**Addendum # 1**  
**File # 16-0499 (REBID)**  
**Energy Efficiency Lighting Project**

**PROJECT:** City of Duluth Energy  
Efficiency Lighting Project

G&M Project No. 84493

**DATE:**  
August 30, 2016

# E100

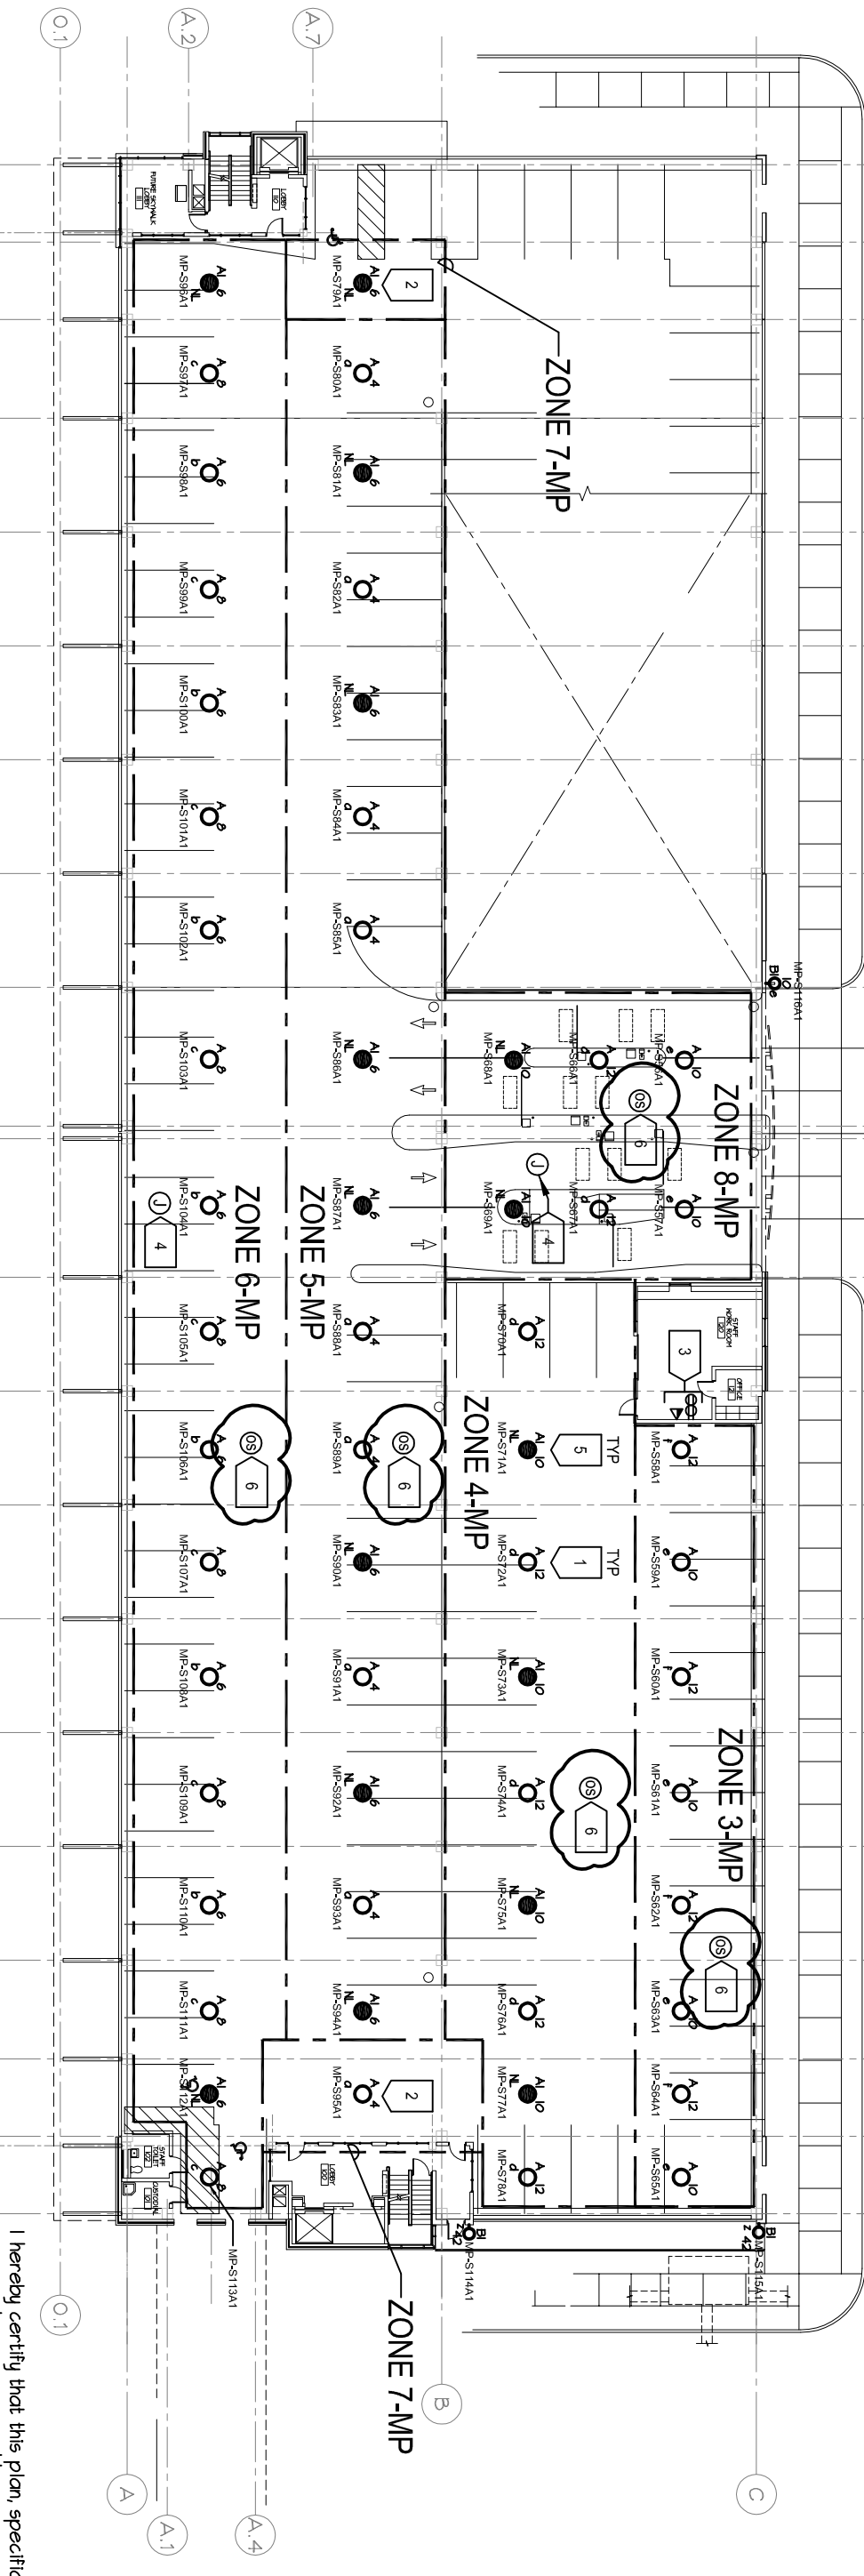
1. Sheet E100
  - Add numbered notes 4 and 5 as shown clouded on plan.
  - Add occupancy sensors as shown clouded on plan.
  - Revise lighting control matrix as shown clouded on plan.

- 3 PROVIDE WIRELESS PHOTOCELL AS MANUFACTURED BY ACUTITY BRANDS CONTROLS OR APPROVED EQUIVALENT. VERIFY EXACT LOCATION PRIOR TO INSTALLATION.
- 4 PROVIDE WIRELESS OCCUPANCY SENSOR(S) ASSOCIATED WITH RESPECTIVE ZONE(S) FOR CONTROL. COORDINATE EXACT LOCATION AND QUANTITIES WITH LIGHTING CONTROL MANUFACTURER.

- 5 PROVIDE DEDICATED 120V, 20A QUAD RECEPTACLE (CONNECTED TO NEAREST 120/208V PANEL, WITH 20A SPARE BREAKER) AND VOICED/DATA/TALENT OUTLET FOR WIRELESS LIGHTING CONTROL SYSTEM GATEWAY (ECHELON LUMEWAVE SYSTEM). VERIFY EXACT LOCATION OF GATEWAYS WITH OWNER PRIOR TO ROUGH-IN.

E101 SCALE: 0' 32'

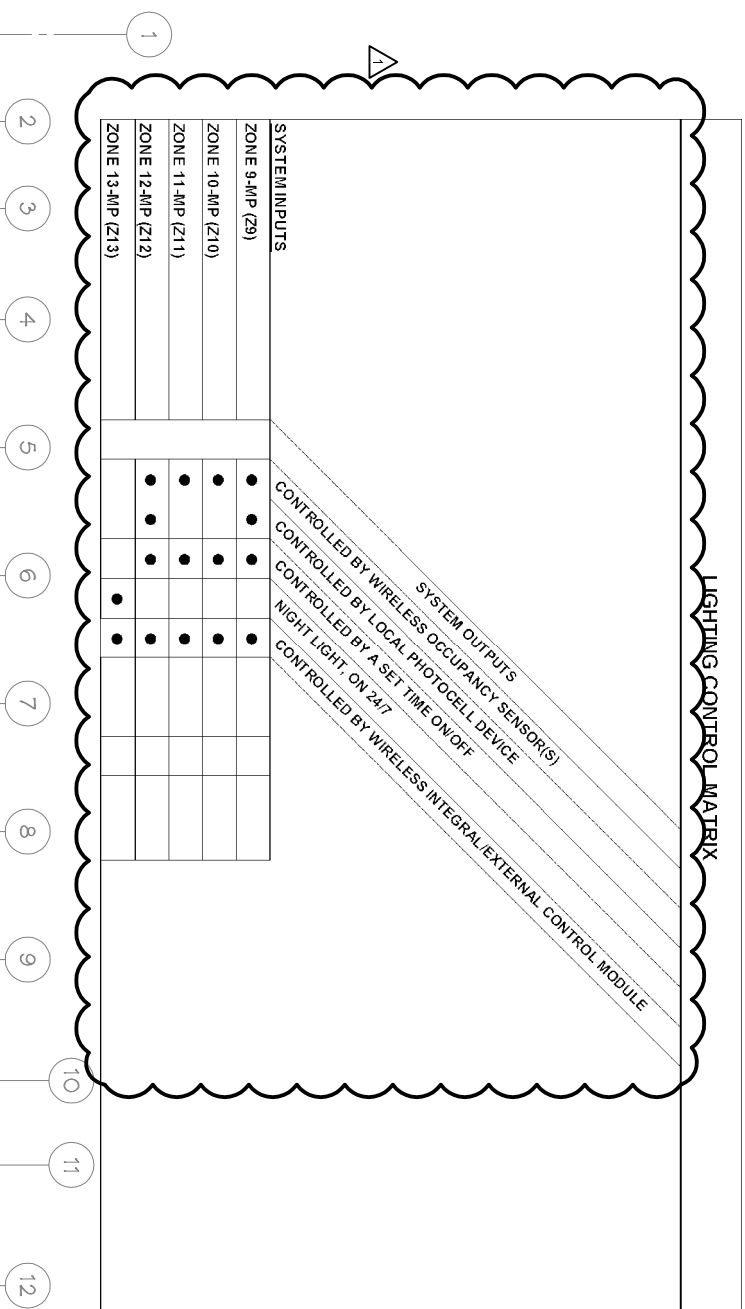
- Revise numbered note 1 as shown clouded on plan.
2. Sheets E101
  - Add numbered note 6 as shown clouded on plan.
  - Add occupancy sensors as shown clouded on plan.

- Revise lighting control matrix as shown clouded on plan.
  - Revise numbered notes 1 and 2 as shown clouded on plan.
3. Sheet E102
  - Add numbered notes 5 and 6 as shown clouded on plan.

- 6 PROVIDE WIRELESS OCCUPANCY SENSOR(S) ASSOCIATED WITH RESPECTIVE ZONE(S) FOR CONTROL. COORDINATE EXACT LOCATION AND QUANTITIES WITH LIGHTING CONTROL MANUFACTURER.

# E102

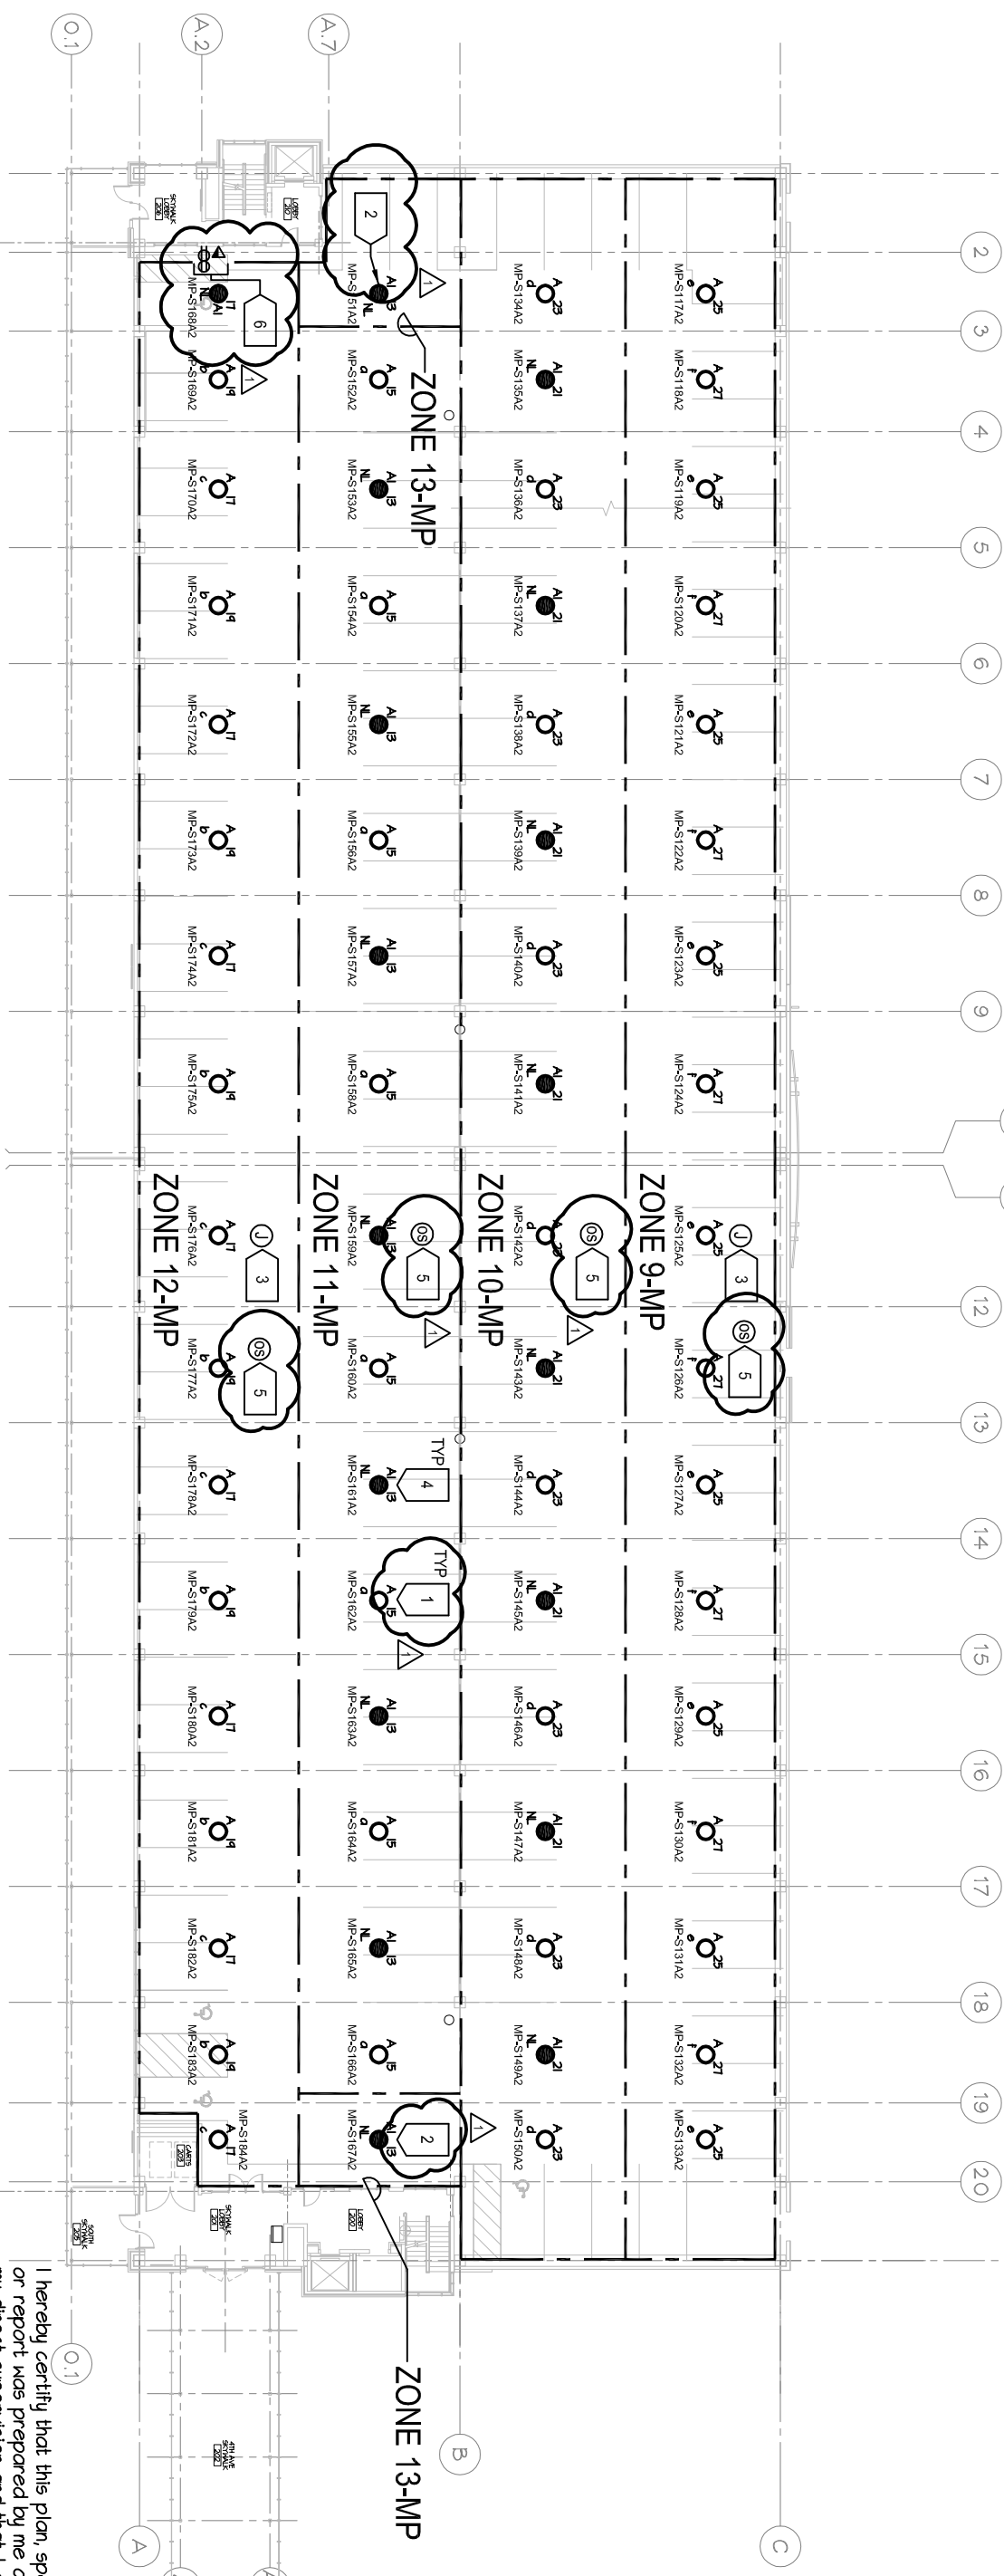
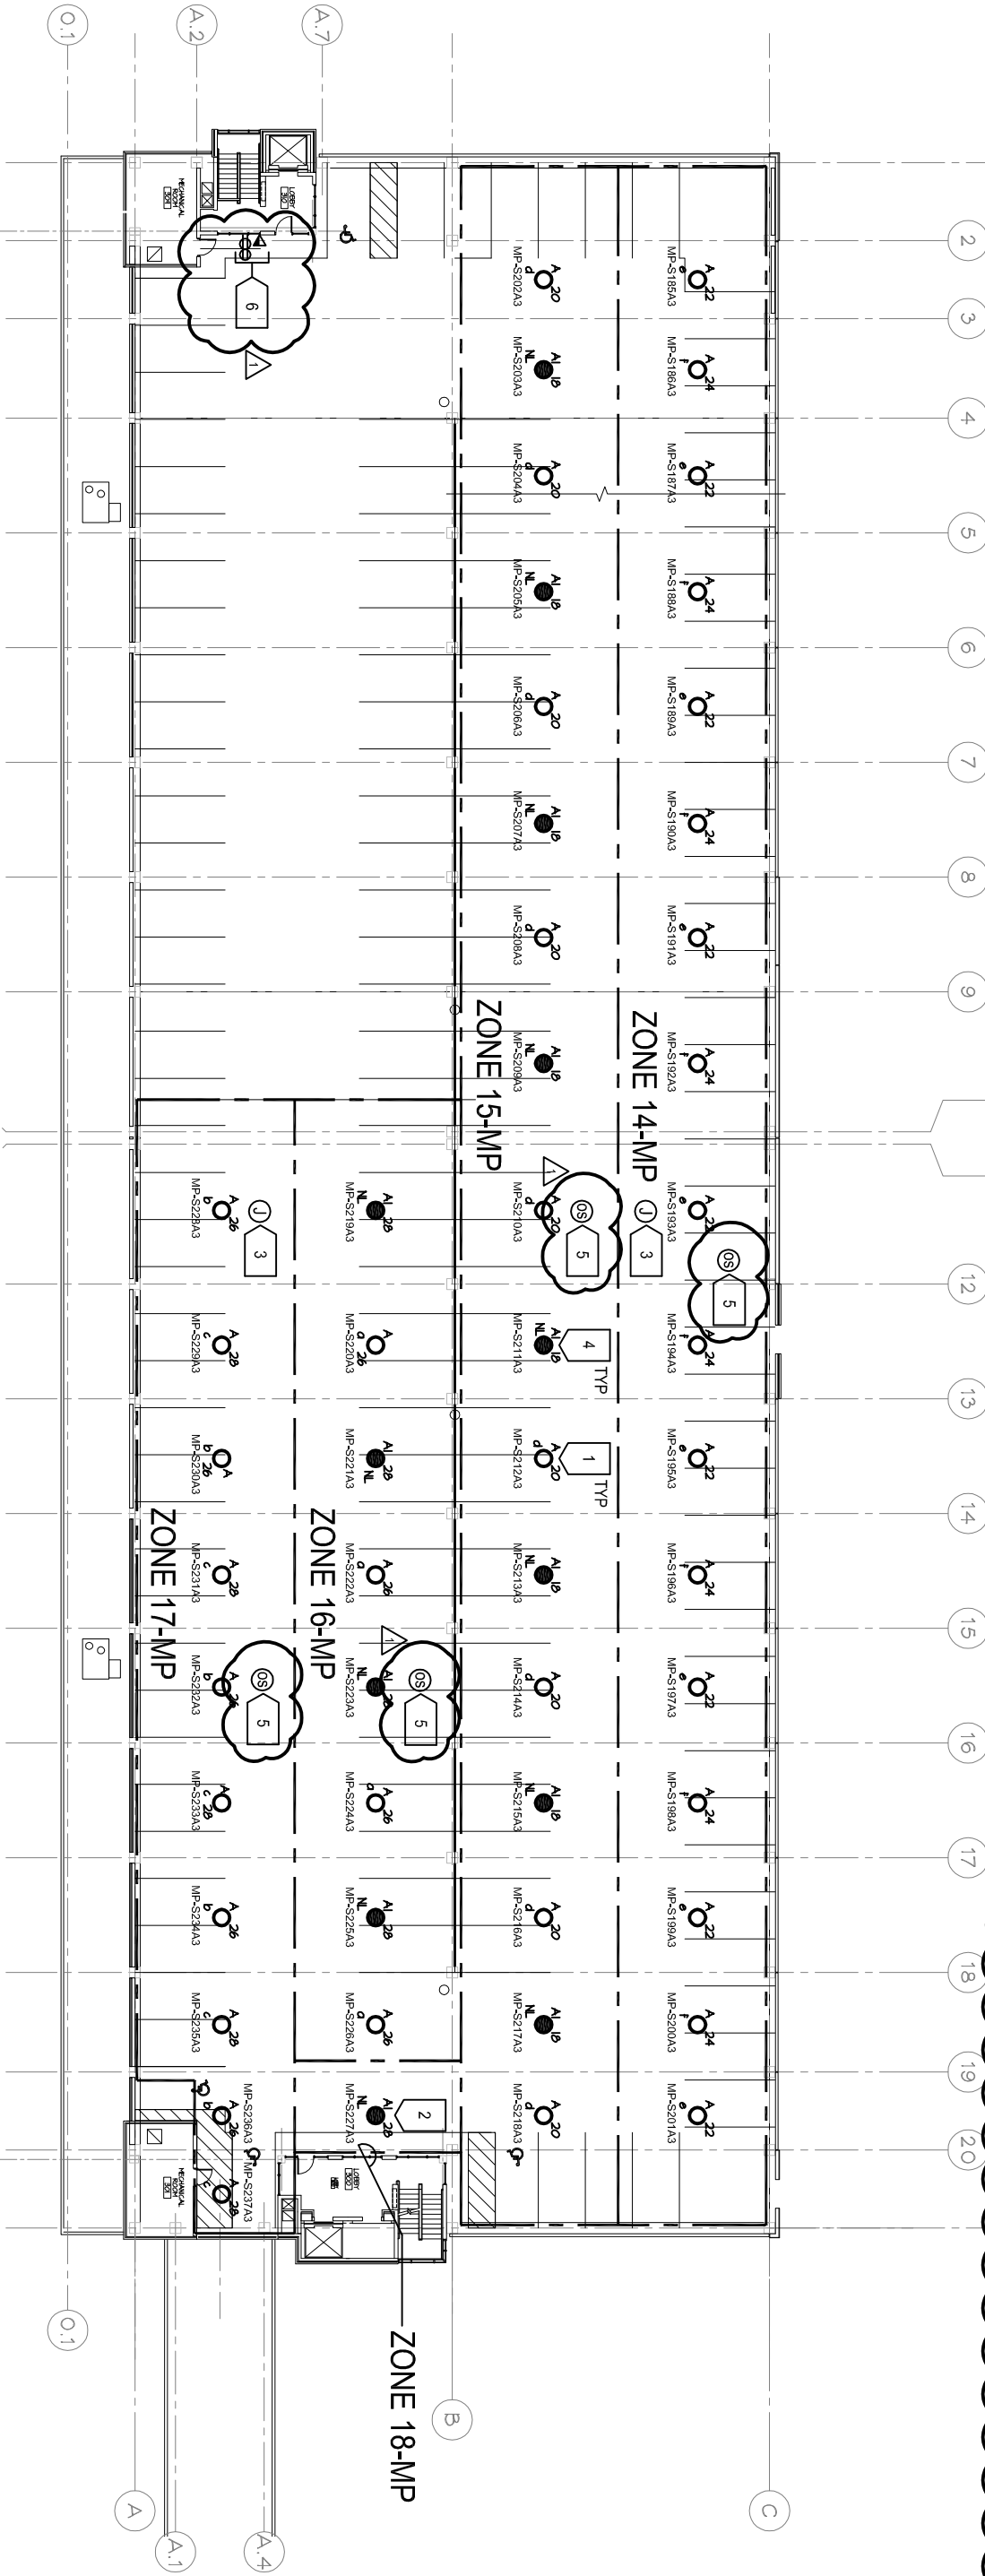
- Add occupancy sensors as shown clouded on plan.
  - Revise lighting control matrix as shown clouded on plan.
  - Revise numbered notes 1 and 2 as shown clouded on plan.

- 4 TYPICAL. ALL FIXTURES INDICATED WITH 'NL' WILL NOT BE NIGHT LIGHTS UNLESS NOTED OTHERWISE.
  - 5 PROVIDE WIRELESS OCCUPANCY SENSOR(S) ASSOCIATED WITH RESPECTIVE ZONE(S) FOR CONTROL. COORDINATE EXACT LOCATION AND QUANTITIES WITH LIGHTING CONTROL MANUFACTURER.

- 6 PROVIDE DEDICATED 120V, 20A QUAD RECEPTACLE (CONNECTED TO NEAREST 120/208V PANEL WITH 20A SPARE BREAKER) AND VOICEDATA OUTLET FOR WIRELESS LIGHTING CONTROL SYSTEM GATEWAY (ECHELON LUMEWAVE SYSTEM). VERIFY EXACT LOCATION OF GATEWAYS WITH OWNER PRIOR TO ROUGH-IN.
